Work Order ID 77294

Item ID: D3166-3 Accept ***N900040100*** Setup Start ***NS1***
 Revision ID: Stop ***NS2***
 Item Name: Basket Hoop
 Start Date: 01/12/2011 Start Qty: 6.00 ***6*** Cust Item ID:
 Required Date: 07/12/2011 Req'd Qty: 6.00 ***6*** Customer:
 Reference:

DESIGN #	DRAWN BY CP	DART AEROSPACE LTD HAWKESBURY, ONTARIO, CANADA	
CHECKED #	APPROVED #	DRAWING NO. D3166	REV. A SHEET 1 OF 1
DATE 02.07.10		TITLE BASKET HOOP	SCALE NTS
A	02.07.10	NEW ISSUE	
A1	04.04.08	38+/-1 WAS 36.0

DRAWING NO. D3166	TITLE BASKET HOOP	REV A1	DART AEROSPACE LTD ENGINEERING ORDER		D.E.O. NO. D3166-A-2	SHEET NO. 1 OF 1	SCALE NTS
DRAWN AJS	CHECKED 1	MFG. APPR. M	APPROVED M		DE APPR. H		
DATE 08.12.11	DATE 08.12.15	DATE 08/12/15	DATE 08/12/16		DATE 08.12.16

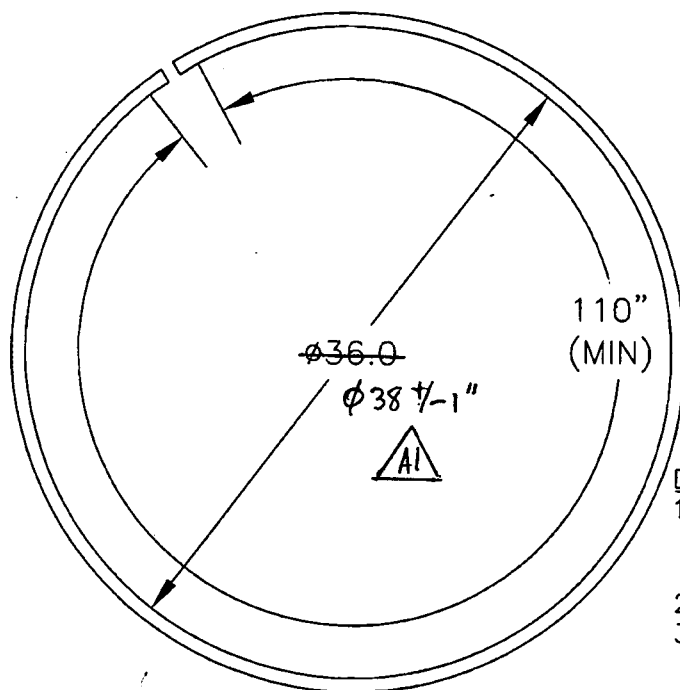
10.6 (REF, NEED 8.0 MIN)

1) MODIFY MATERIAL NOTE FOR D3166-1 AS SHOWN:

2) MODIFY MATERIAL NOTE FOR D3166-3 AS SHOWN:

IS:

- 1) MATERIAL: AISI 304/316 SS, 3/4 X 3/4 X 0.065 WALL SQUARE TUBING,
60.00" LONG
REF. DART SPEC M304TS0.750W.065

IS:

- 1) MATERIAL: AISI 304/316 SS, 3/4 X 3/4 X 0.065 WALL SQUARE TUBING,
120.00" LONG
REF. DART SPEC M304TS0.750W.065
